Access Compliance Report

Public Rights-of-Way

(Curb Ramps)

Intersection ID: 50563	Main Street: MORGAN_CREEK_DR	Cross Street: SMOKE_MONT_DR	Location: NE
ADA ID: D1F78E4C6C95	Ramp Type: Perp	Initial Pass/Fail: Fail	Overall Compliance: No
Severity Score: 21.25			
Codes/Mitigation Info/Possible Solution		Field Measurements/Component Compliance

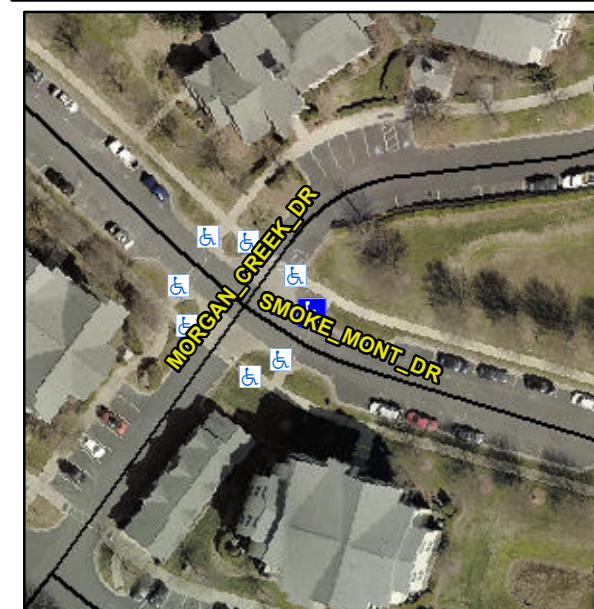
Not Found, R304.5.1, R304.2.2

Compliance	Description	Data	Compliance	Description	Data
N/A	Ramp Length (in)	60.0	No	Ramp Slope (%)	9.1
No	Ramp Width (in)	47.5	Yes	Ramp XSlope (%)	0.5
N/A	Flare Type LT	N/A	N/A	Flare Type RT	N/A
N/A	Flare Slope LT (%)	N/A	N/A	Flare Slope RT (%)	N/A
N/A	Flare Traversable LT?	N/A	N/A	Flare Traversable RT?	N/A
N/A	Landing Length (in)	N/A	N/A	DWS Provided?	N/A
N/A	Landing Width (in)	N/A	N/A	DWS Contrast?	N/A
N/A	Landing Slope (%)	N/A	N/A	DWS Length (in)	N/A
N/A	Landing X Slope (%)	N/A	N/A	DWS Full Width?	N/A
N/A	Landing Curb? (Y/N)	N/A	N/A	DWS Offset (in)	N/A
N/A	Shared Landing?	N/A			
N/A	Gutter Ponding?	N/A	N/A	Gutter Slope (%)	N/A
N/A	Gutter Lip Ht (in)	N/A	N/A	Gutter X Slope (%)	N/A
N/A	Painted X Walk1?	Yes	N/A	Painted X Walk2?	N/A
	X Walk 1 Direction	To SW		X Walk 2 Direction	N/A
N/A	X Walk 1 Width (in)	45.0	N/A	X Walk 2 Width (in)	N/A
	X Walk 1 Slope (%)	2.3		X Walk 2 Slope (%)	N/A
	X Walk 1 X Slope (%)	1.2		X Walk 2 X Slope (%)	N/A

Remove & Replace Entire Ramp.
